विषय:- जनपद बागेश्वर के अन्तर्गत बालीघाट-धरमघर-खन्तोली पुल से गुरगुच्छा प्राप्त स्कूल तक मोटर मार्ग के निर्माण हेतु 0.63 हेतु 0.63 है वन भूमि के प्रत्यावर्तन के सम्बन्ध में। (Online Proposal No. FP/UK/ROAD/12710/2015).

वन एवं पर्यावरण मंत्रालय भारत सरकार की आपत्ति के बिन्दु संख्या 1 के कम में
आख्या

Geological Site Assessment of 3.0 Km long Khitoli Bridge to Gurkucha Motor Road Alignment Corridor between CH 0.0-3.0 Km, Kapkot Block, District Bageshwar (Kumaon)

Closer Satellite view of the site

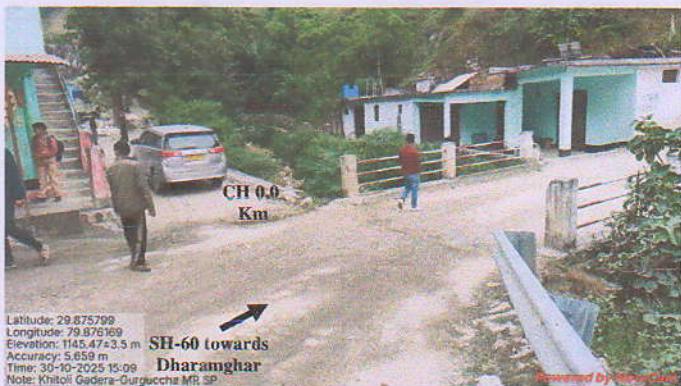
Alignment-1 diverts from CH 59 Km of SH-60 near right abutment site of Khitoli motor bridge and is 3.0 Km in length, it does not have any hairpin bends and the gradient of this alignment is level to 1:20, 1:24 & 1:60 of rising gradient and 1:40 of falling gradient. This alignment has already been found geologically suitable by Mr. Vijay Dangwal (Ex. Senior Geologist) of PWD. Accept that the alignment intersects an old muck dumping zone (initial ~50 m) for which suitably designed protection measures are to be taken.

Alignment-2 diverts from CH 59 Km of SH-60 near left abutment site of Khitoli motor bridge and runs parallel to the alignment-1. It is also 3.0 Km in length and it has 01 hairpin bend with level to 1:15 and 1:20 of rising & 1:20 of falling gradient and 1:40 gradient at the hairpin bend but the initial slope that this alignment intersects is steep and the alignment at its CH 0.040 Km intersects a temple. Therefore, alignment-2 also does not seem to be suitable for the construction of the motor road.

Alignment-3 diverts from CH 57 Km of SH-60 ~1.8 Km before Khitoli motor bridge. It is 2.0 Km in length and it has as many as 06 hairpin bends which repeat on the same slope one over the other. Also the gradient of this alignment is very steep. In order to improve the gradient and to decrease the no. of hairpin bends the arms of the alignment are to be stretched after which the alignment will have to cross the nap land of village Chaura for which the residents of the village did not agree. Therefore, alignment-3 does not seem to be suitable for the construction of the motor road.

6- Conclusion: On the basis of the geological observations/studies carried at the site and with the above recommendations, the alignment-1 site proposed for 3.0 Km long Khitoli Bridge to Gurkucha motor road was found geologically suitable construction between CH 0.0 to 3.0 Km.
